**PLANNED UNIT DEVELOPMENT
STAFF REPORT****Date: June 5, 2014****DEVELOPMENT NAME**

Dunaway Corporation.

LOCATION421 Holcombe Avenue
(Northeast corner of Holcombe Avenue and Granger Street).**CITY COUNCIL
DISTRICT**

Planned Unit Development Approval to allow multiple buildings on a single building site.

SITE PLAN

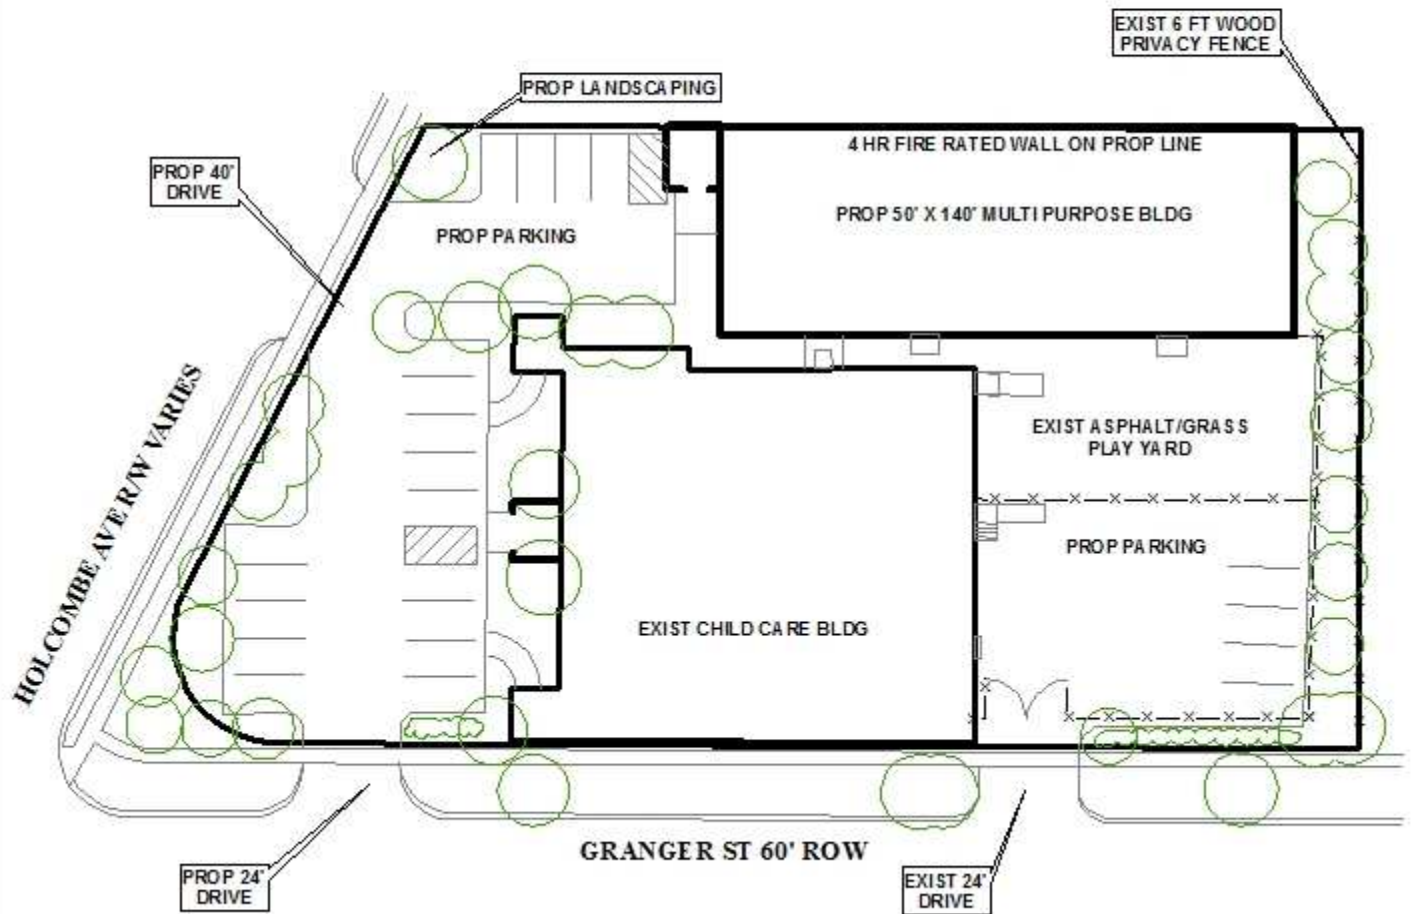
It should be pointed out that the site plan illustrates a total of 3 curb-cuts, 1 proposed along Holcombe Avenue and 2 to Granger Street-- 1 existing and 1 proposed. This is of significance because the number of curb-cuts is being reduced from 4 to 3. A condition of approval from the previously mentioned Subdivision request limited the site to the existing curb-cuts; however, as the number of curb-cuts is being reduced, a new Subdivision application should not be required at this time.

The proposed parking/access and maneuvering areas appear to be compliant as the multi-use facility will not increase the parking requirements for the site for the proposed use; however, the site plan should be revised to illustrate the proposed vehicular traffic circulation throughout the site.

The site plan does not clearly depict the location of any existing or proposed dumpsters on the property. The site plan should be revised to illustrate the location of a dumpster in compliance with Section 64-4.D.9. of the Zoning Ordinance, or a note stating that garbage collection will be via curb-side pick-up

In reference to tree and landscaping compliance, landscaping is illustrated on the site plan; however, 7 frontage trees appear to be depicted within the right-of-way and, as such, may not be counted towards the required number of frontage trees. Also, it should be pointed that there is an existing utility pole and line which runs south across Granger Street near the vicinity of the proposed curb-cut to Granger Street. The applicant should keep in mind that any trees planted within 15' of above-ground utility lines **must** be live oak trees. Therefore, the site plan should be revised to illustrate live oak trees but if the applicant desires a different type of frontage tree, they should be depicted a minimum distance of 15' from the overhead utility lines.

Overall, the site and tree plan should be revised to illustrate full compliance with the Frontage Tree requirements of the Zoning Ordinance, to include the required 9 frontage trees for Holcombe Avenue, 5 frontage trees for Granger Street and 13 perimeter trees. All other landscaping appears to exceed the minimum tree and landscaping requirements of the Zoning Ordinance.

Any new lighting on the site will have to comply with the requirements of Sections 64-4.A.2., 64-6.A.3.c., and 64-6.A.8. of the Zoning Ordinance. A note reflecting this requirement should appear on the site plan, and photometric plans will be required at the time of permitting.

Finally, it should be noted that there was no signage information provided, but, as this site is a single-tenant location, the site is limited to a total of 3 signs, as defined in Section 64-11. of the Zoning Ordinance. The applicant should keep in mind that the location any proposed sign structure, such as a monument or freestanding sign, should be illustrated on a revised PUD site plan, as PUD approval is site plan specific.

- 1) Revision of the site plan to depict the proposed vehicle circulation throughout the site;
- 2) Revision of the site plan to depict the location of a dumpster in compliance with Section 64-4.D.9. of the Zoning Ordinance, or a note stating that garbage collection will be via curb-side pick-up;
- 3) Revision of the site plan to comply with the Frontage Tree requirements of the Zoning Ordinance;

- 4) Revision of the site plan to illustrate live oak trees within 15' of above-ground utility lines. All other species of frontage trees should be depicted a minimum distance of 15' from said utilities;

- 5) Revision of the site plan to illustrate any proposed sign structure;
- 6) Placement of a note on the site plan stating that any new lighting on the site must comply with the requirements of Sections 64-4.A.2., 64-6.A.3.c., and 64-6.A.8. of the Zoning Ordinance and submission of a photometric plan of the entire site at time of permitting;
